PREMIER SALES GALLERY

SITE VISIT ON 2021-11-29

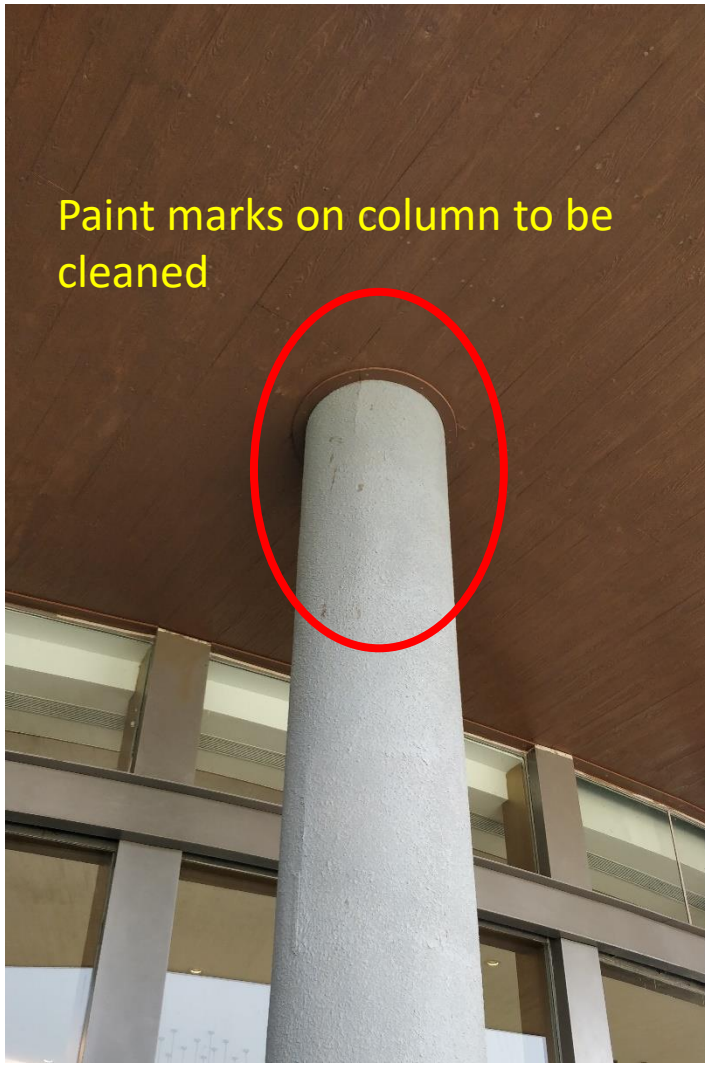
Paint was looking patchy
Also screw marked were visible
To be sealed with matching paint

Gap to be filled with bison board/ façade flashing

Paint to be finished properly

Colour of the joint to be matching with cladding
To minimised the visibility.

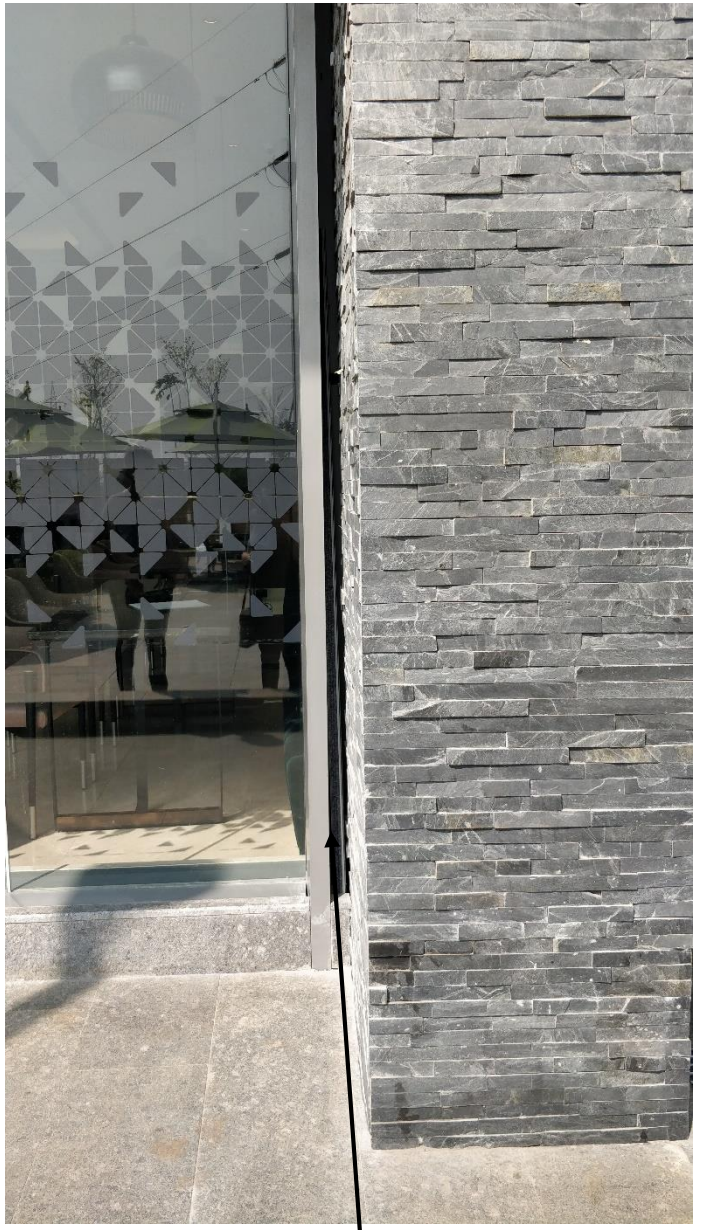
Frame welding to be cleaned and polished finished with RAL 7024/ matching to the façade cladding
Cladding has been broken at the tie member junction
Glass to be cleaned

Ideally same cladding and fin to be continued till floor

Gap to be cleaned and maintained properly.
Façade team to confirmed if that can be sealed/ filled

Stain marking to be cleaned

This walls to be painted with same shade of exterior round columns

To be packed with exterior grade bison board finished with paint

All these base stone to be cleaned and painted

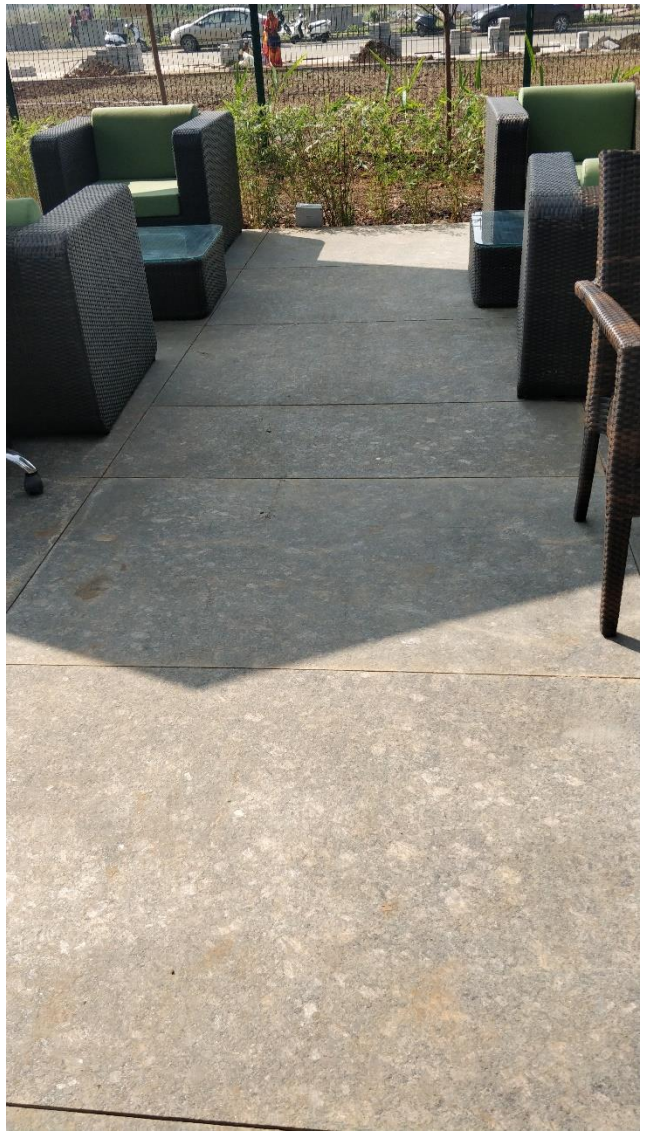
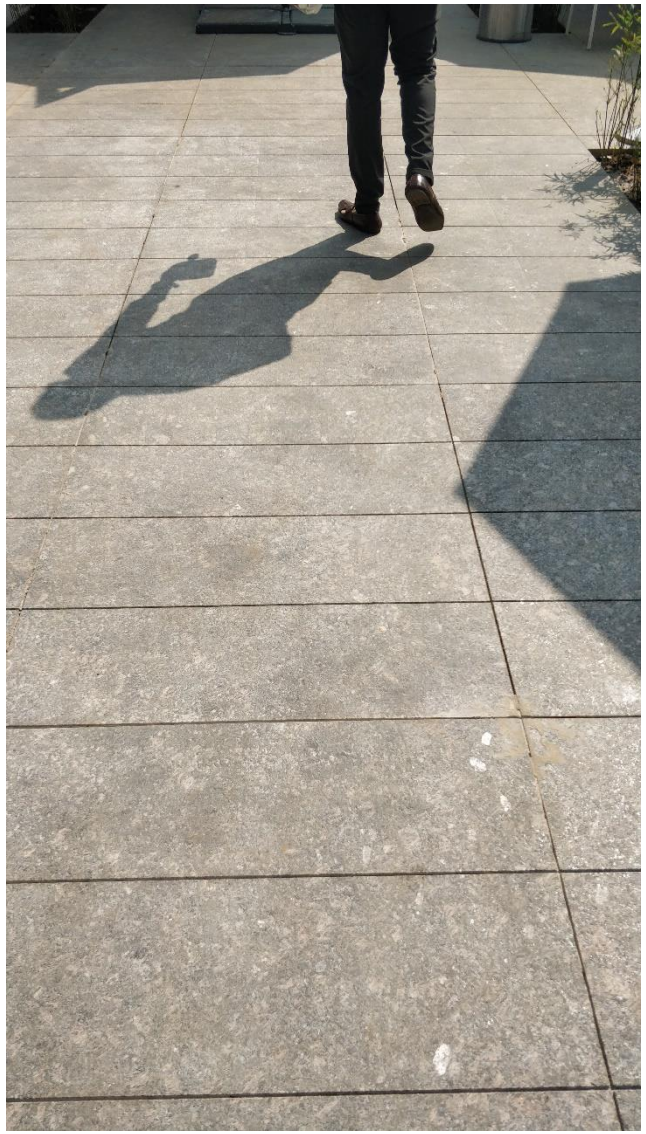
Pebbles are missing at rear side. Refer Landscape drawing for the extent

Offset at the bottom of the cladding to be min. tile thickness only. Please rectify.
Plinth protection to be continued all across.

Tile joints are not as per drawing. Please follow flooring pattern as per drawing.
Joints to be filled with grout matching to the granite.

Lawn to be added between the gaps of the steps

Gutter is visible from the distance,
please rectify.

Edge detail given but not executed , hence border started cracking. please rectify.

Cracks started developing in the parking area

Broken plinth protection tile to be replaced.

Civil work to be finished and painted around the pipe. Pipe to be concealed in the soil and plinth protection tile to be continued.

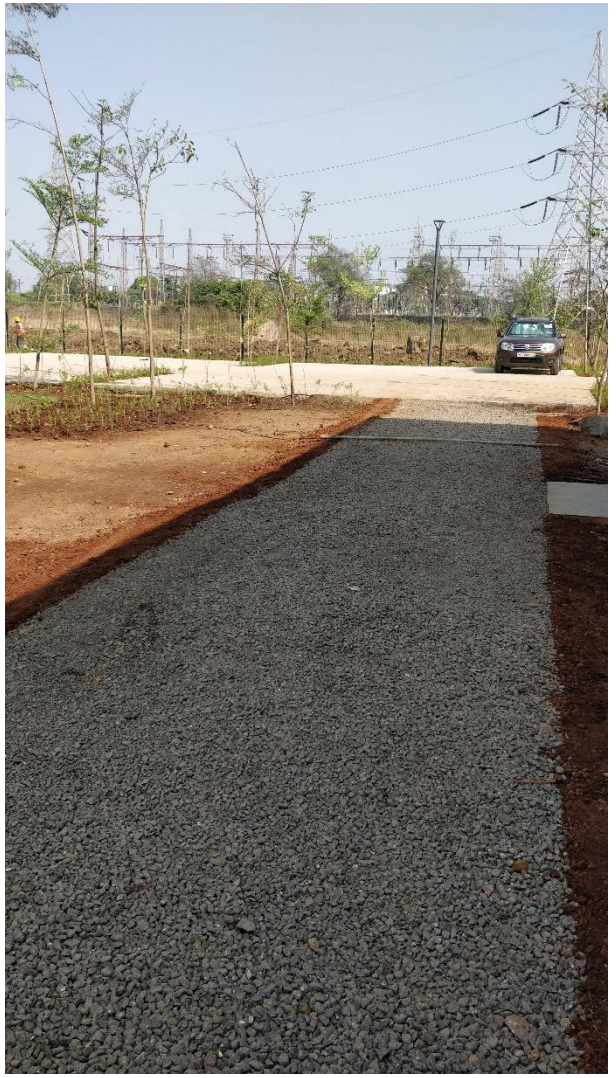
Aerator pipe need to be below water level

Soil alignment to be same across the plinth protection line.
Drop of plinth protection is missing

This are plantation is pending.

Charu walkway and plantation is pending.
